**HISTORIC LANDMARK COMMISSION**  
**APPLICATION FOR A CERTIFICATE OF APPROPRIATENESS**  
**FEBRUARY 28, 2022**  
**CASE NUMBER C14H-1977-0015**  
**REVEREND JACOB FONTAINE GOLD DOLLAR BUILDING**  
**2402 SAN GABRIEL STREET**

**PROPOSAL**

Remove ca. 1942 enclosure and return the second-floor balcony to its ca. 1923 appearance.

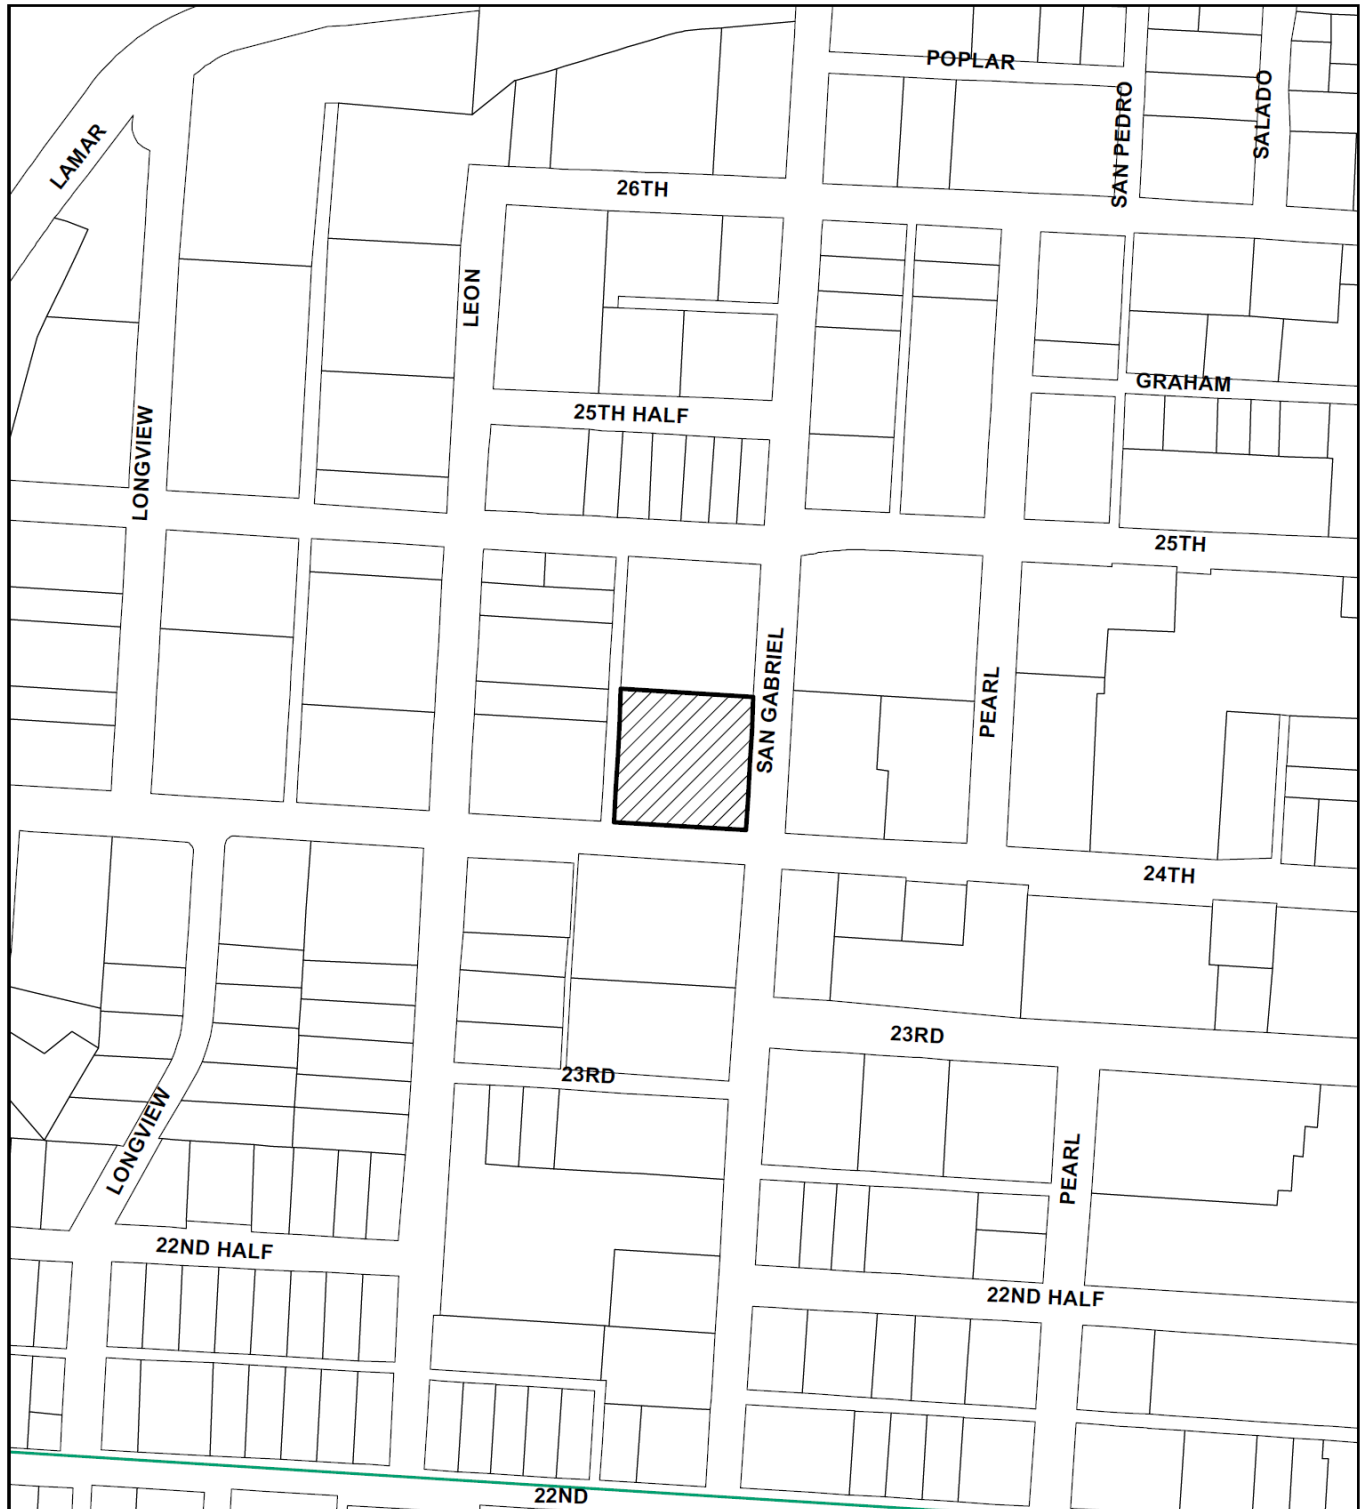
The applicant’s initial proposal was to remove the second-floor balcony in its entirety and install a new metal railing to create an outdoor seating area. Committee members indicated the need to restore the building to a particular point in time based on documentary and physical evidence or keep it as is. At the second meeting, the applicant indicated willingness to revise his plans to retain the columns and roof of the earlier open balcony, though the revised drawings had not been developed by that time. Committee members provided input on design details, such as examining for a fascia board at the roof and looking for physical evidence to inform the railing design.

Carefully consider whether removal of the ca. 1942 balcony enclosure is appropriate. If so, approve the revised drawings, and authorize staff to approve a final railing design after additional demolition has occurred.
